Instructions for Handling Attached Correction  
and Additions to Supplement No. 1 to  
Economic and Environmental Impacts of Alternative  
Closed-Cycle Cooling Systems for Indian Point  
Unit No. 2

Question III.12

Figure 2. Vegetative Habitat and Areas of Maximum Saline Deposition: Natural Draft, 14 Rainless Days. (Based on Dames & Moore, 1973).

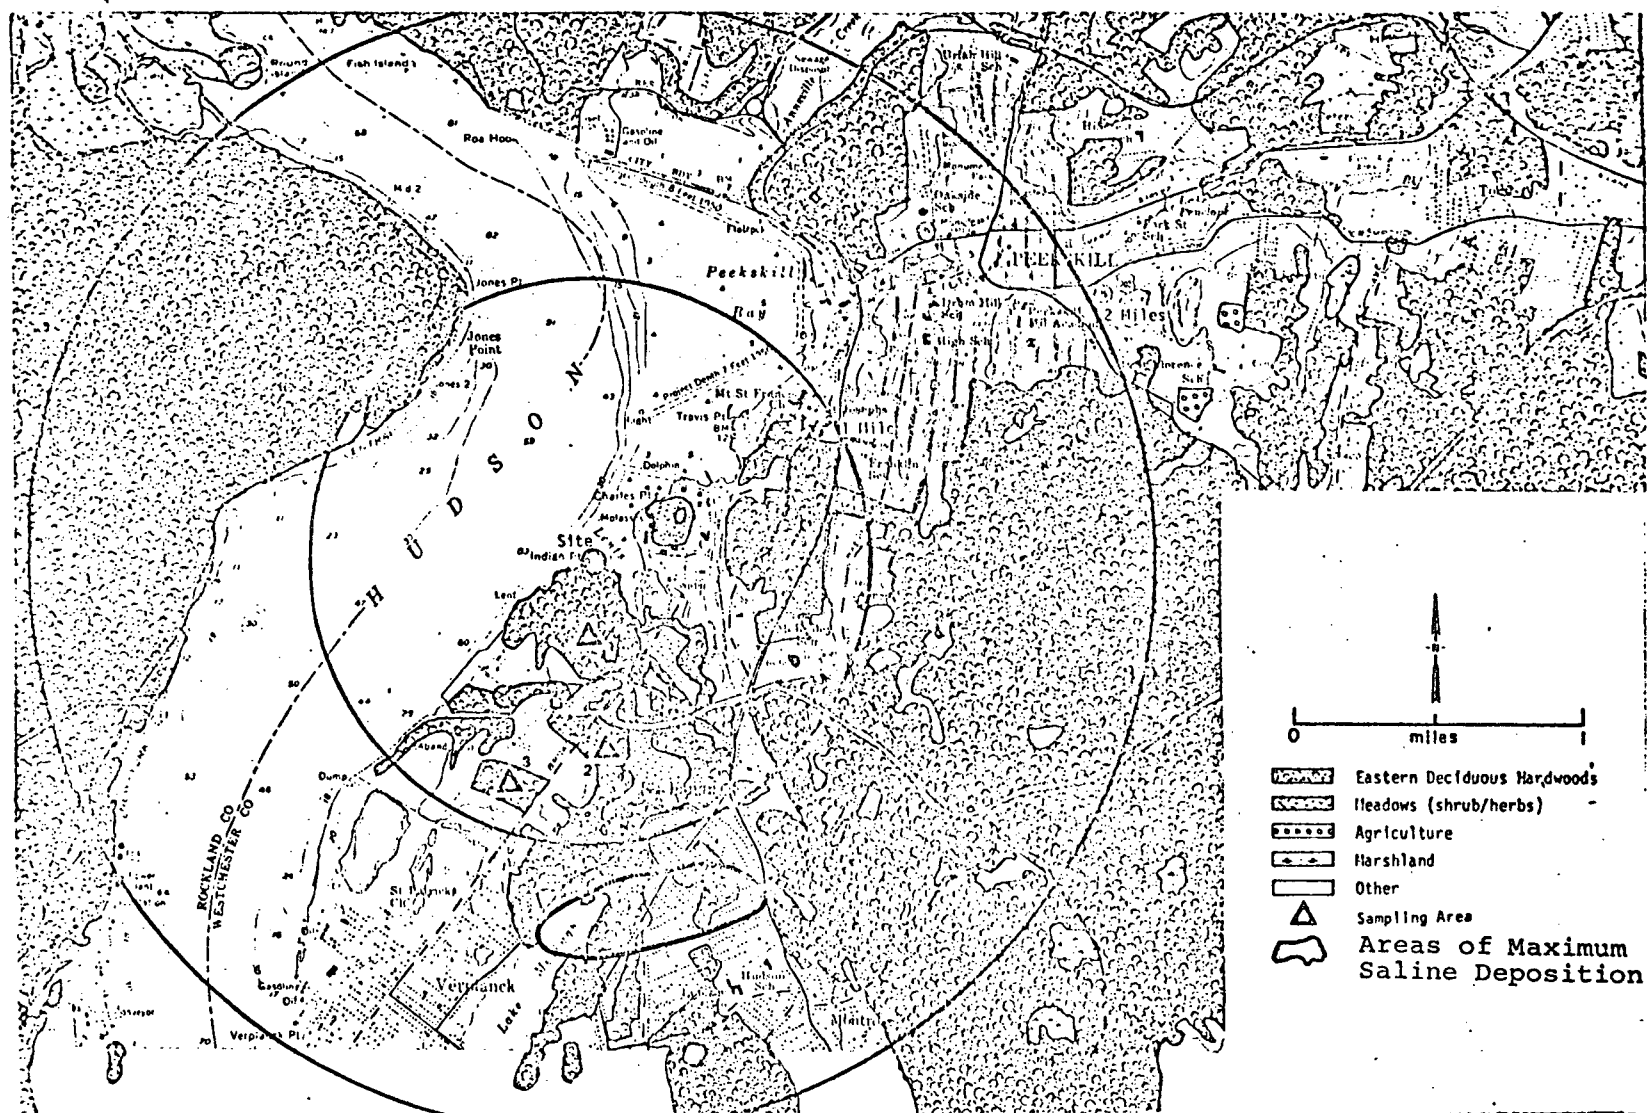
Provide a descriptive analysis of the vegetative habitat at the regions of maximum predicted salt deposition. This information need only be of reconnaissance-level type.

Figures 1 and 2, which are based on the 1973 Dames and Moore report (Appendix D of the Indian Point Unit No. 2 cooling tower report) depict the relationship between vegetative habitats within a two mile radius of Indian Point and the approximate size and location of maximum salt deposition areas. These areas are predicted to be susceptible to injury from salt drift from a mechanical draft or a natural draft cooling tower at Indian Point, assuming 14 consecutive rainless days. The vegetative habitats in the maximum salt deposition areas consist of combinations of 4 basic cover types:
